ADDENDUM NO.1

SULLIVAN MIDDLE SCHOOL ATHLETIC RESTROOM/CONCESSION BUILDING

ROCK HILL SCHOOLS
BID PACKAGE 1:
BID # 19-2024 SITE PREPARATION & UTILITY CONNECTIONS

February 25, 2020	VOLUME 1 OF 1	APN # 593120
-------------------	---------------	-----------------

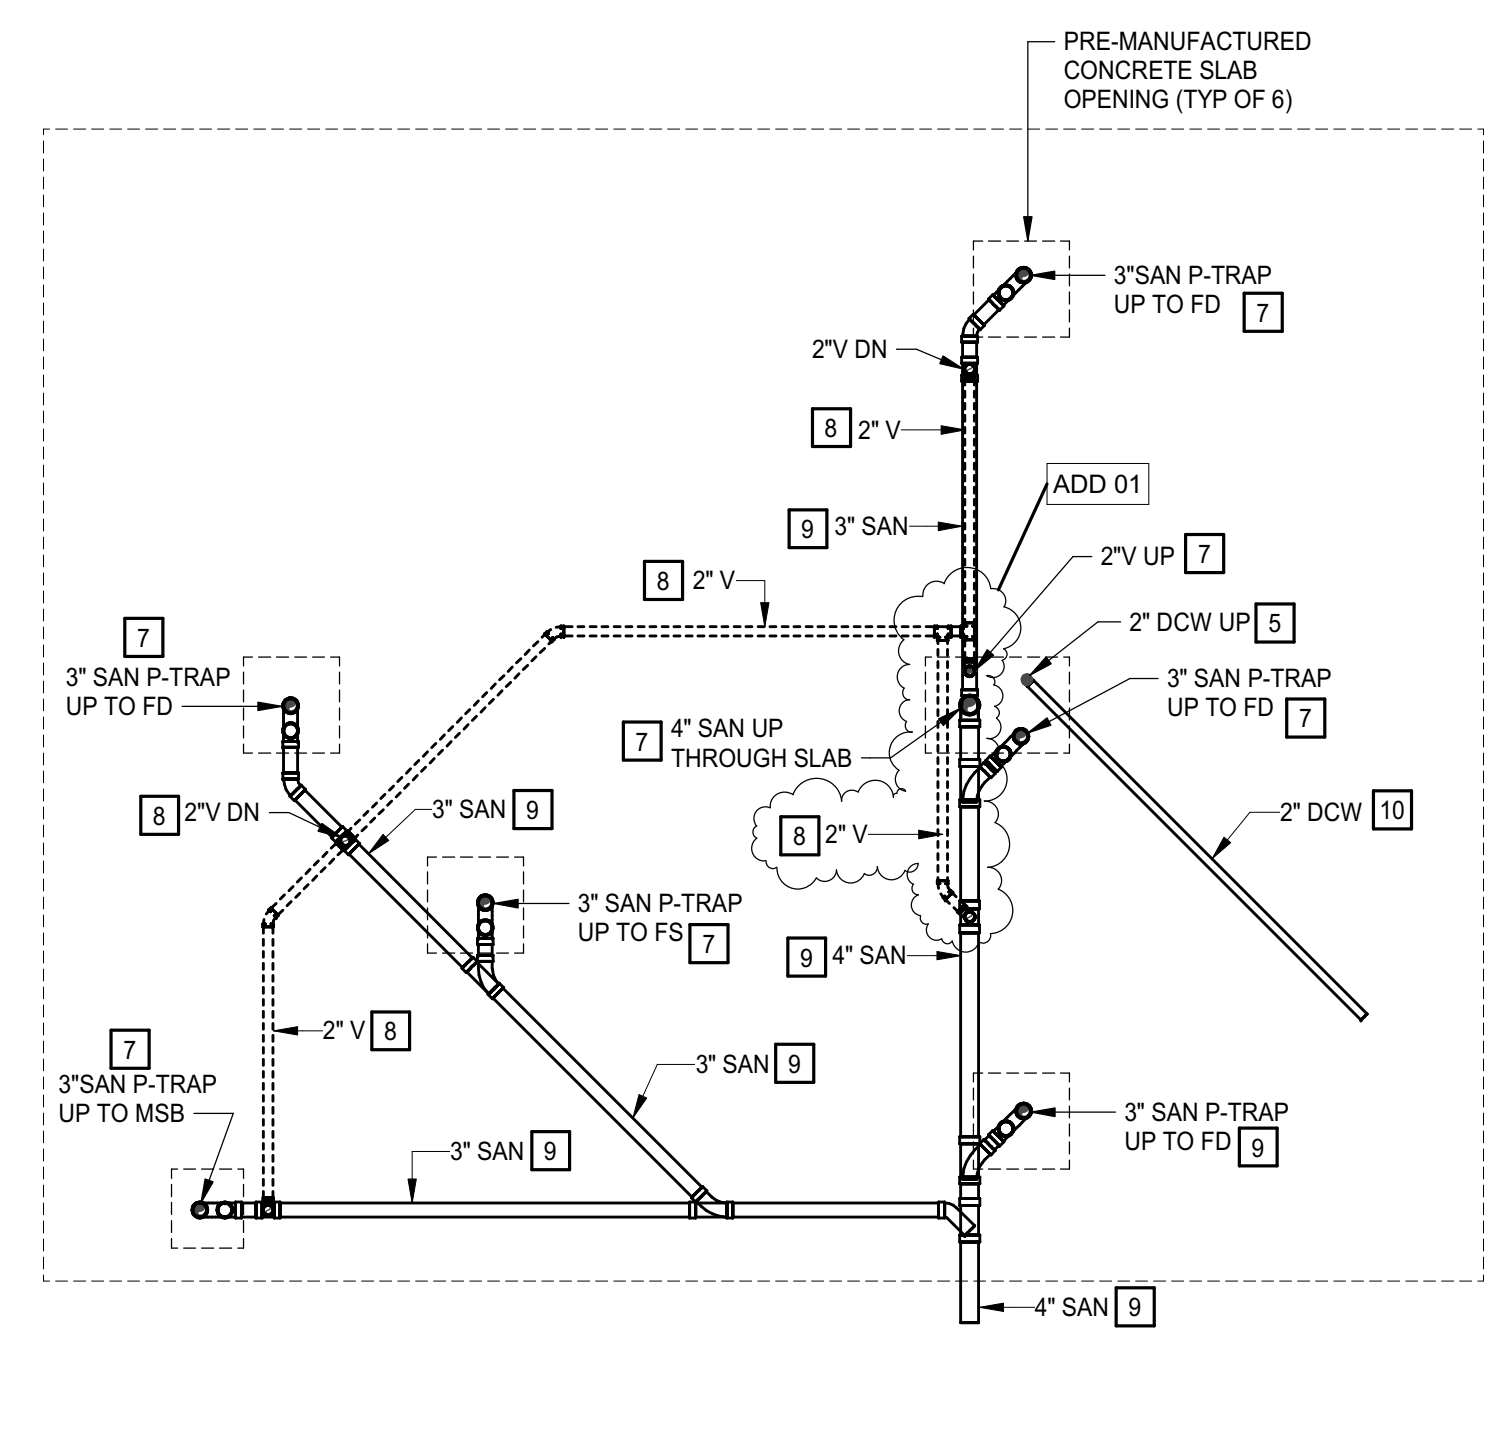
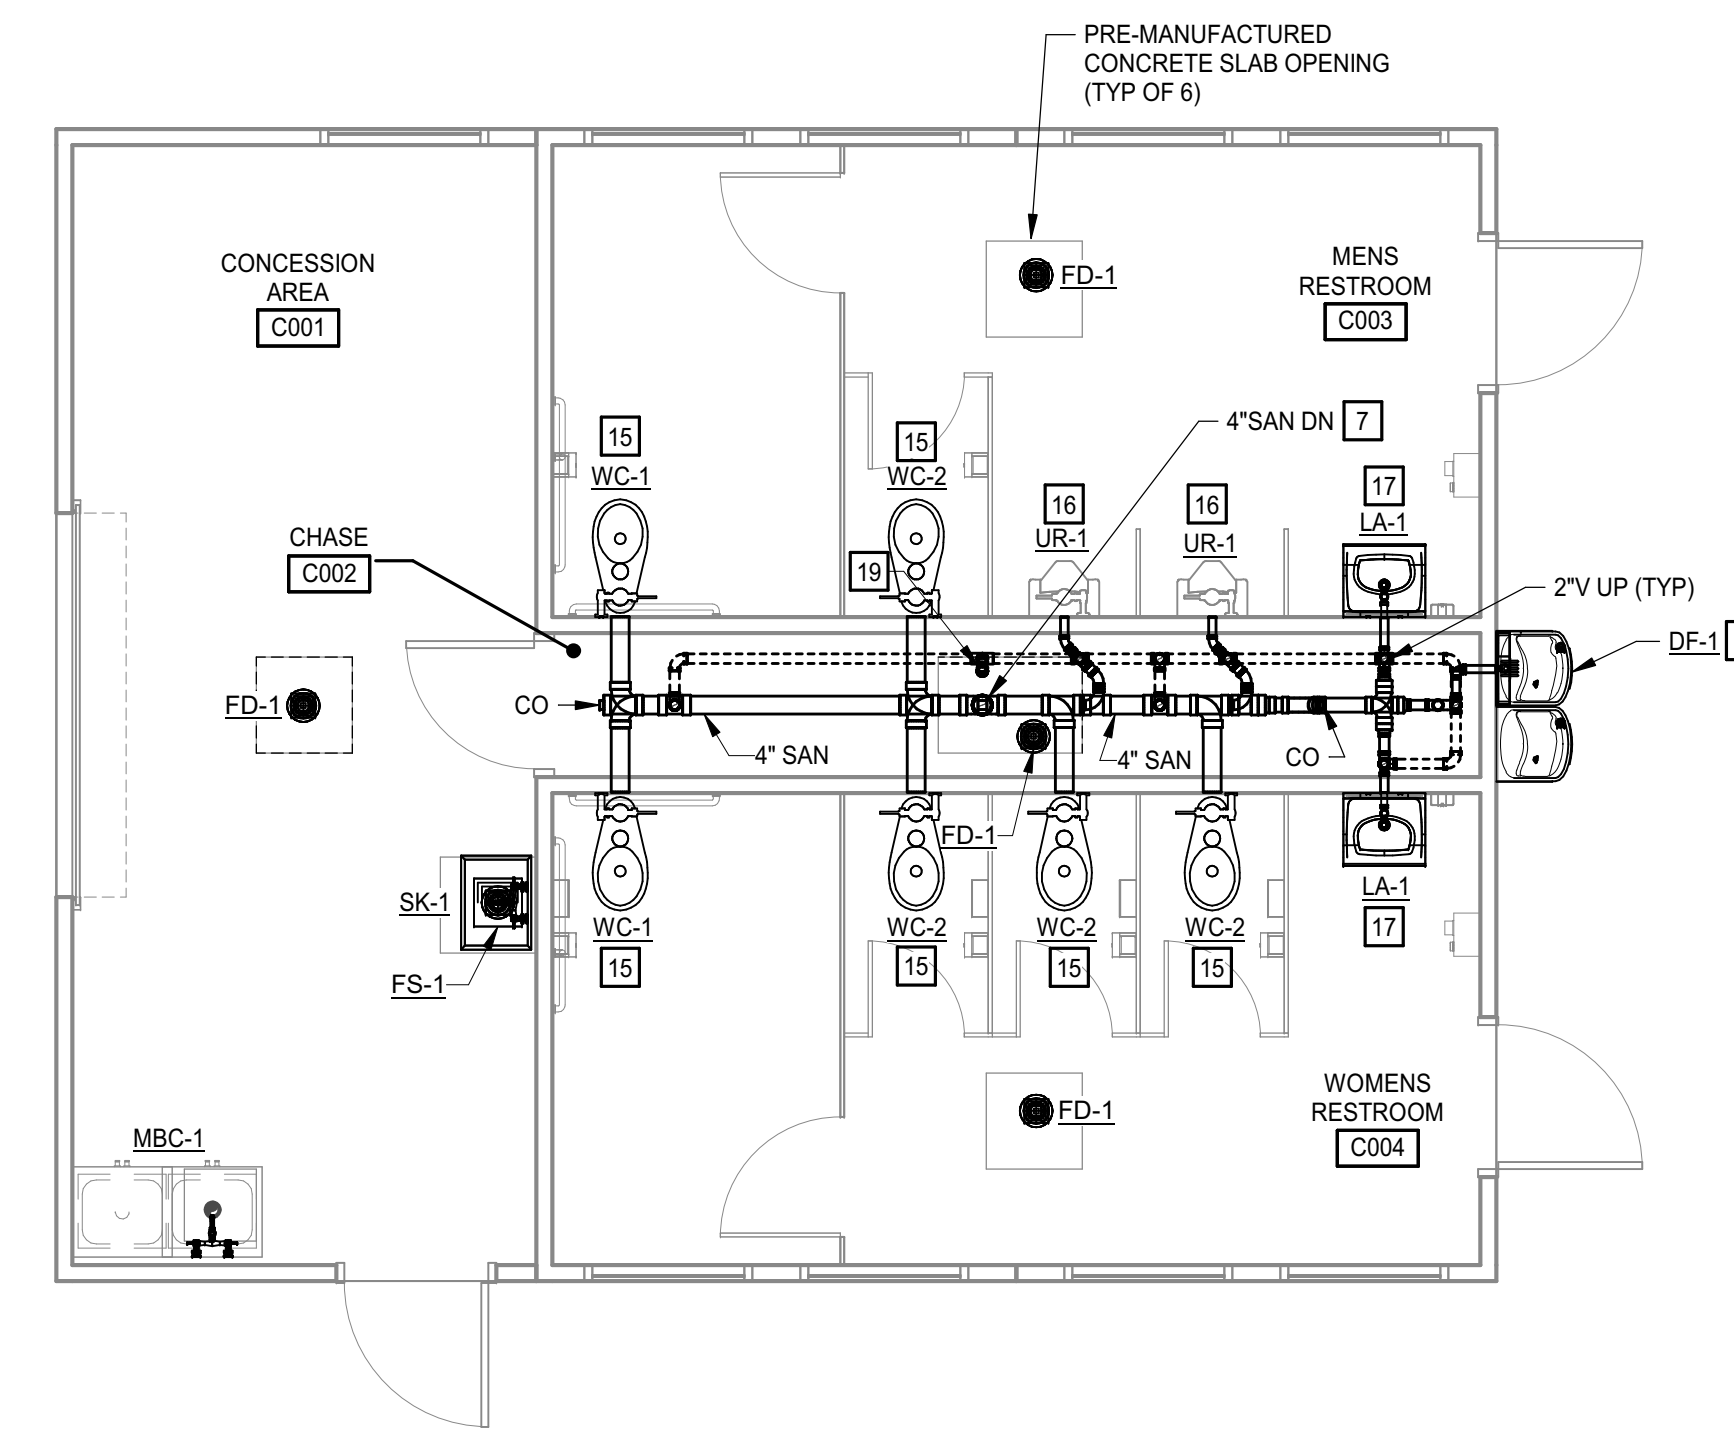
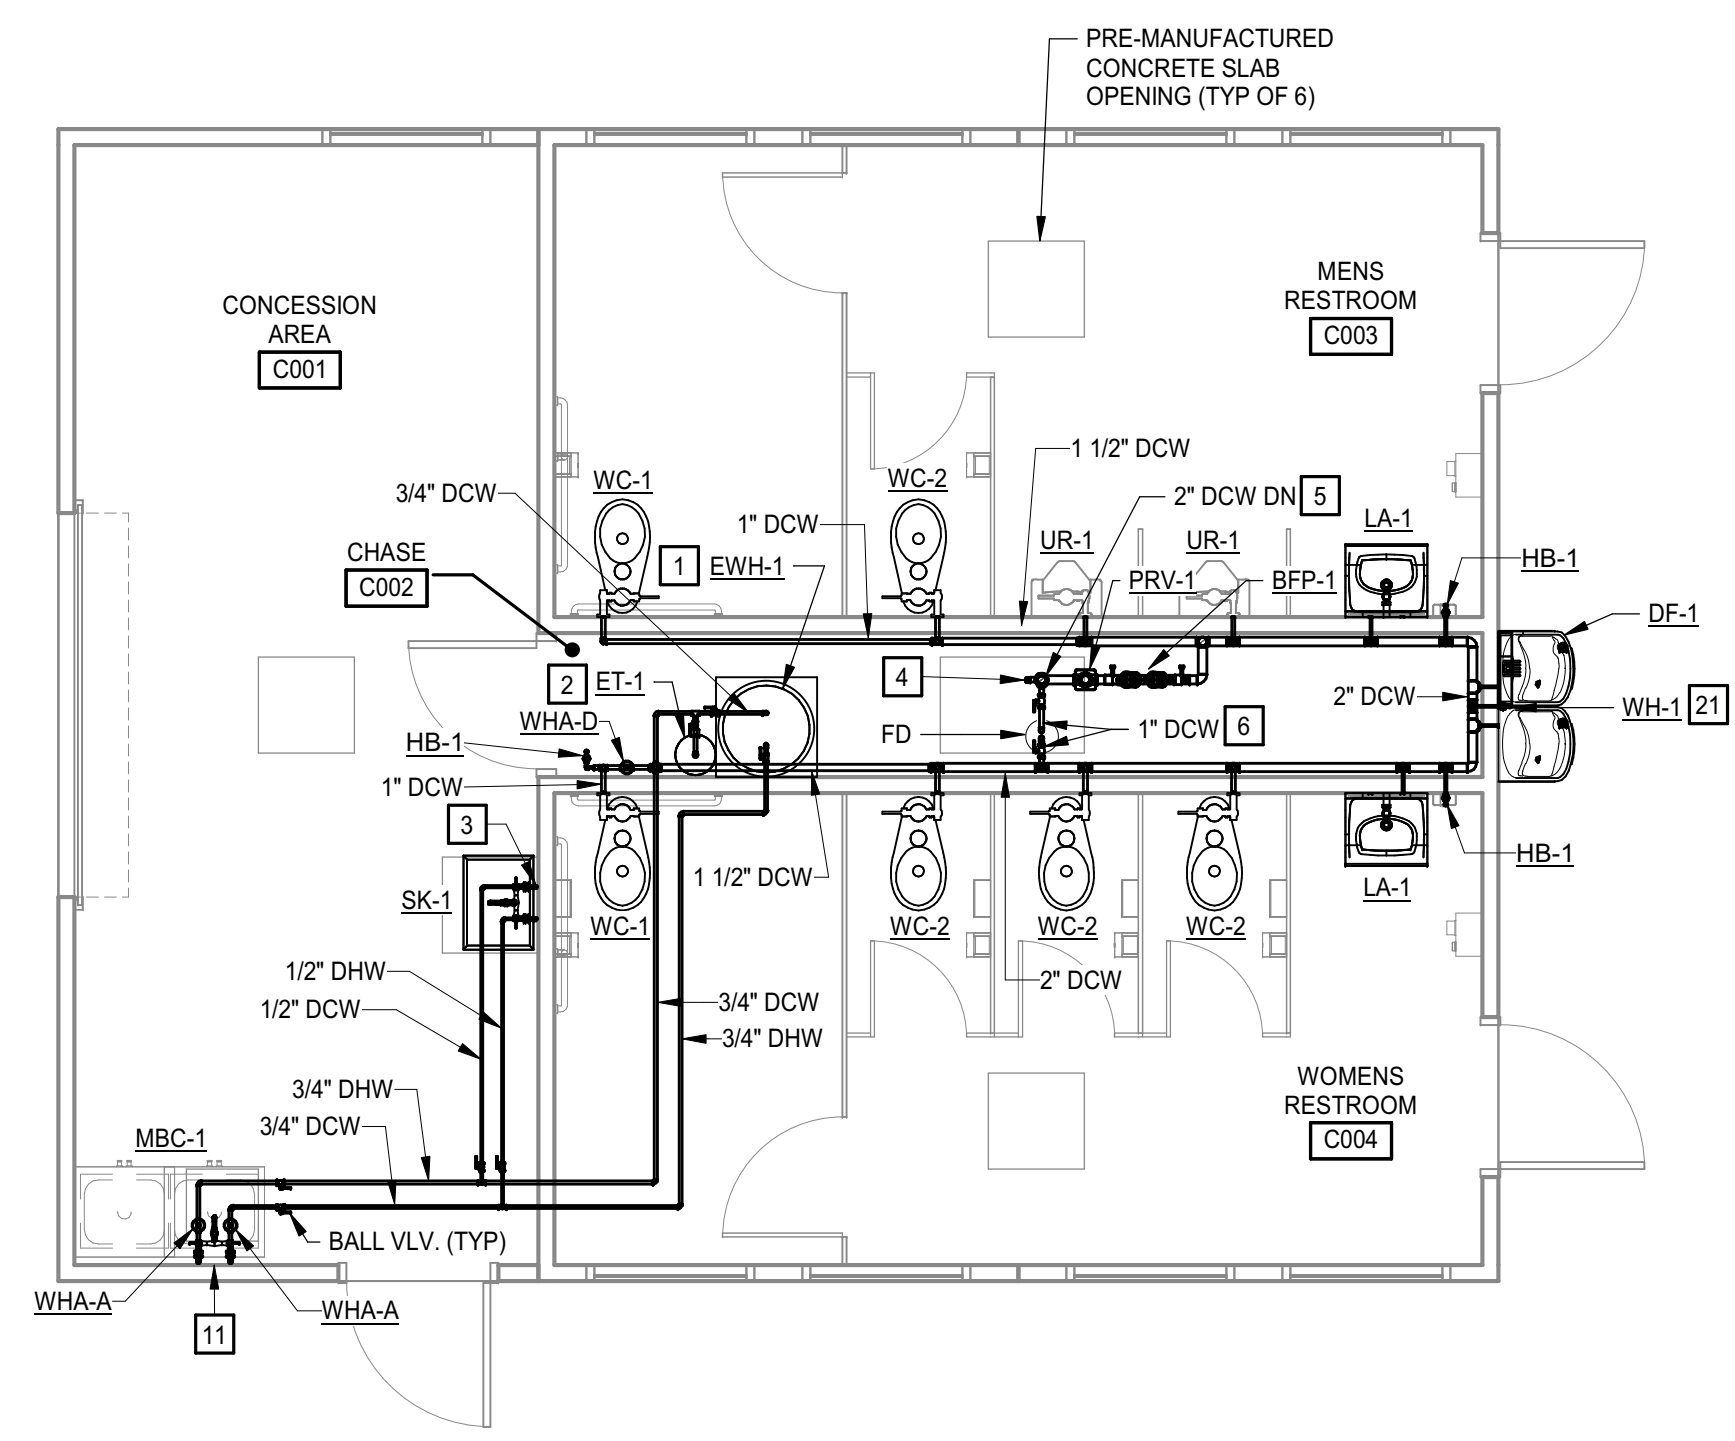
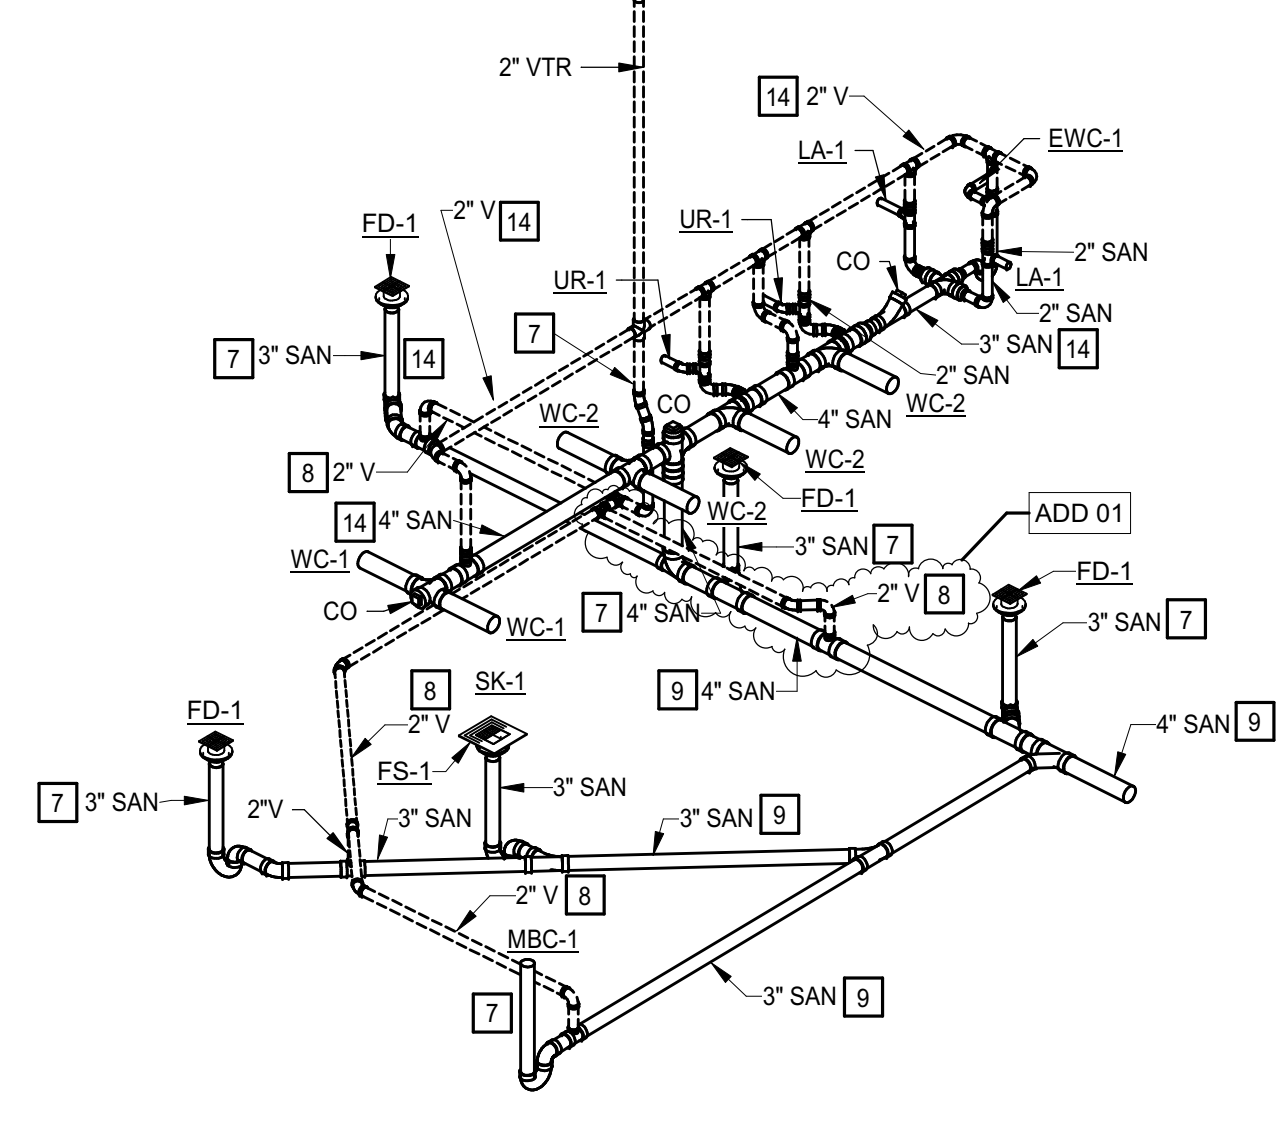
- 15) How will the FD-1 in the chase, as well as Women's C004, be vented? Which of the two trap primers or trap guards to be used on the floor drains?
- a. The new under-slab vent is shown on plans as ADD 01.
 - b. Trap Guards shall be installed along with deep seal p-traps on ALL floor drains and floor sinks per Plumbing drawing P2.0.1, Drain, and Cleanout Schedule.
- 16) Substitution Request: Machflow had drier in lieu of Xlerator.
- a. Approved Substitution
